June 2010 Glitch & Fix

Radiant Floor Heat And Mod/Con Boilers

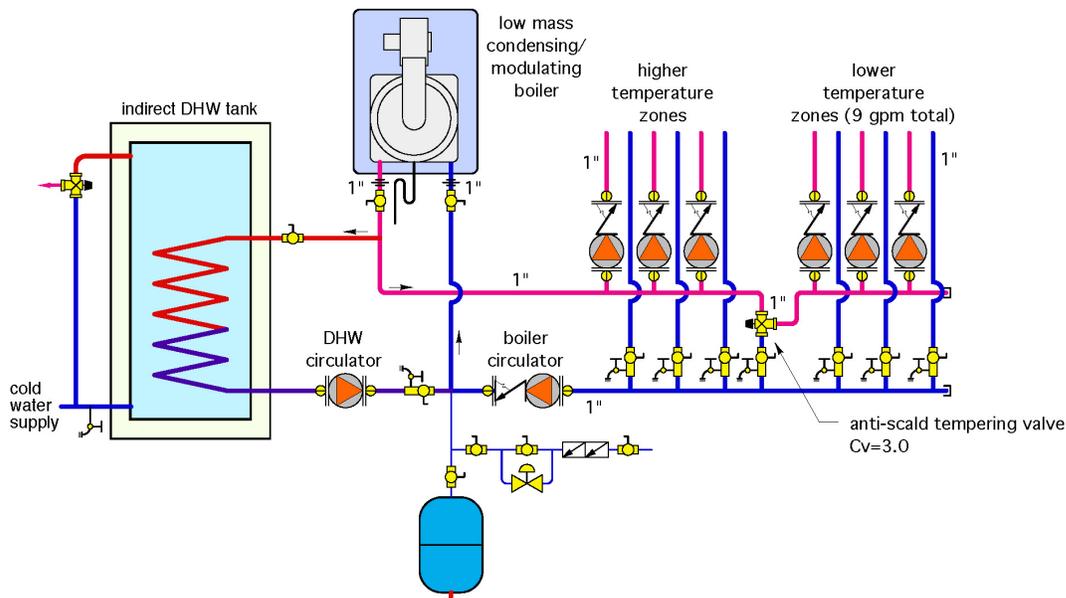
A project requires both medium- and low-temperature radiant floor panels. The installer proposes the following system design. Since the mod/con boiler already has an internal outdoor reset controller, he decides to use a standard 1-inch tempering valve to lower the water supply temperature to the lower temperature zones. He also decides that since the boiler supply and return connections are 1 inch, he can pipe the entire system with 1-inch tubing.

Can you spot at least six design or installation details that are going to create problems?

The header piping in the original design is the same size (1-inch) as the piping to individual zone circulators. This will likely create a high pressure drop when all zone circulators are operating. The pipe size of the distribution headers in the fix drawing has been increased to minimize head loss and, thus, minimize hydraulic interference between zones.

The boiler circulator needs to be hydraulically separated from the circulators in the distribution system. This has been corrected using the closely spaced tees.

The 1-inch tempering valve with $C_v = 3.0$ has been replaced with a properly sized three-way rotary mixing valve with much higher C_v ($C_v = 10$) and hence lower pressure drop. Although a motorized actuator is shown on the mixing valve, it may not be required.

A manually set (nonthermostatic/nonmotorized) three-way valve can provide proportional reset control to the lower temperature zones when the hot water supplied to the valve is reset by the boiler. The motorized actuator is recommended in situations where the lower temperature zones will have frequent setback or temperature adjustment. A check valve is installed in the hot water pipe to the three-way valve to prevent flow reversal when other zones are operating.

- A microbubble air separator has been added such that flow from the boiler passes through it during both space heating and DHW operating modes.
- In the original drawing, the purging valves on the return side of the zone circuits were installed backwards.
- In the original drawing, all zone circulators are shown with very little distance between their inlet port and the header. This distance should be a minimum of 12 pipe diameters to reduce the level of turbulence entering the circulator.
- The DHW circulator in the original drawing lacks a check valve. Without it, there will be some reverse flow through the coil of the indirect water heater when the space-heating portion of the system is operating.
- Finally, the point of no pressure change in the original system is incorrectly located on the discharge side of the circulators.
